February 16, 2022

**Re: Crystal Springs Water District (PWS ID #00386)
West Side Reservoir & Waterlines Phase 2 (PACE Project #17816)
Final Approval – Plan Review #55-2020**

Project Name: West Side Reservoir and Transmission Mains PR# 55-2020
 Public Water System ID# 41-386
 PWS Name: Crystal Springs Water District

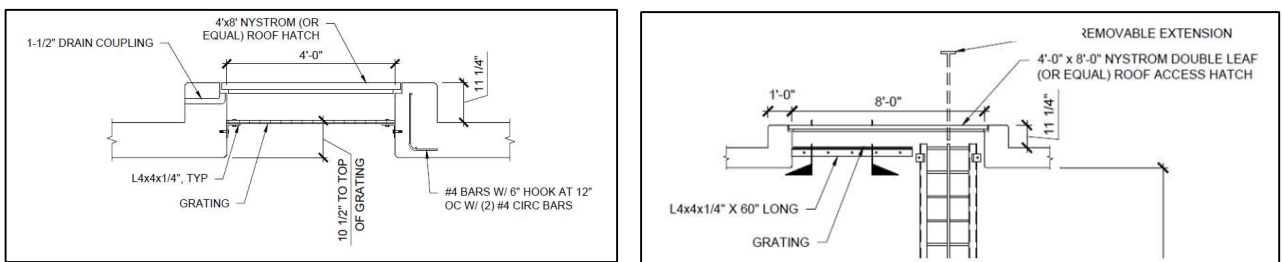
1. An access manhole shall be provided to permit entry to the interior for cleaning and maintenance. When the access manhole is on the roof of the reservoir there shall be a curbing around the opening and a lockable, watertight cover that overlaps the curbing [OAR 333-061-0050(6)(J)]. The proposed hatch did not appear to meet this requirement as shown below:

- 1) A concrete curb was poured around the access hatch on the roof. The access hatch itself has an integral curb with a lockable, watertight cover that overlaps the curb.
- 2) No coating was applied to the interior surface of the storage tank, so this condition is not applicable.
